Joseph M. Farley Nuclear Plant Units 1 and 2
License Amendment Request for Technical Specification Table 3.3.1-1

**Farley Nuclear Plant Units 1 & 2
License Amendment Request for Technical Specification Table 3.3.1-1**

Basis for Proposed Change

Figure A-1

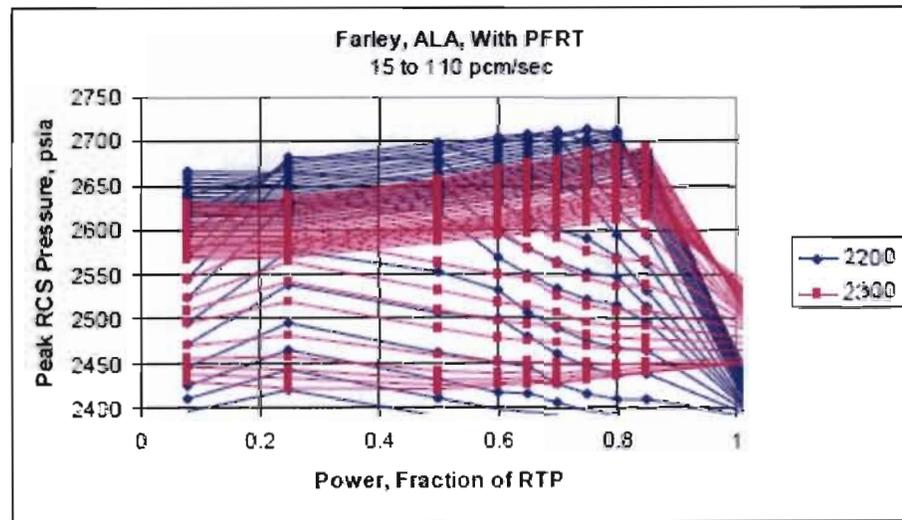
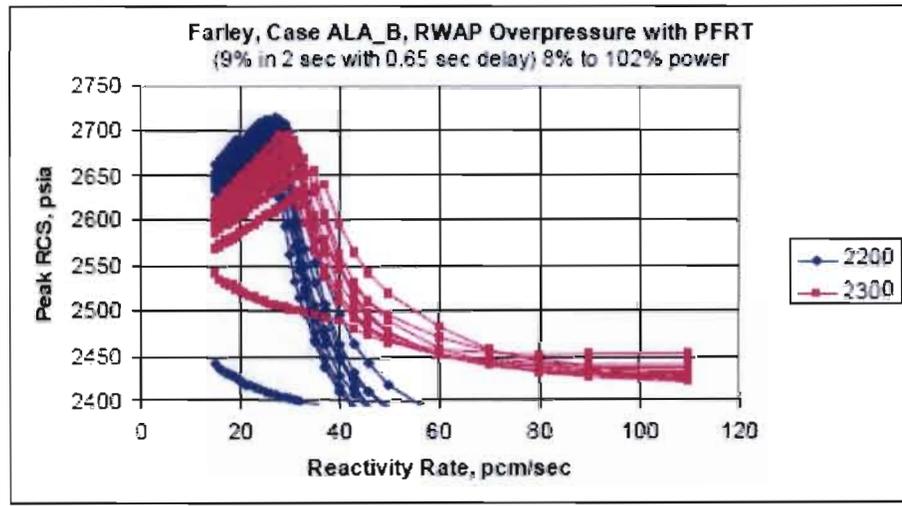
These analyses were based on the key parameters for the Farley units listed on Table A-1. The Farley analyses for a PFRT at 9% of RTP with 0.65 second delay involved 680 individual LOFTRAN computer runs at various initial conditions and reactivity insertion rates. The results are plotted on the attached Figure A-1. Two plots are provided: peak RCS pressure versus reactivity insertion rate; and peak RCS pressure versus initial power level. Both plots are based on the 340 transient calculations starting from a pressurizer pressure of 2200 psia and the 340 transient calculations starting from a pressurizer pressure of 2300 psia. These analyses calculated an acceptable result (i.e., RCS peak pressure not in excess of 2750 psia) with a PFRT at 9% of RTP, a lag time constant of 2.0 seconds, and a trip delay time of 0.65 second.
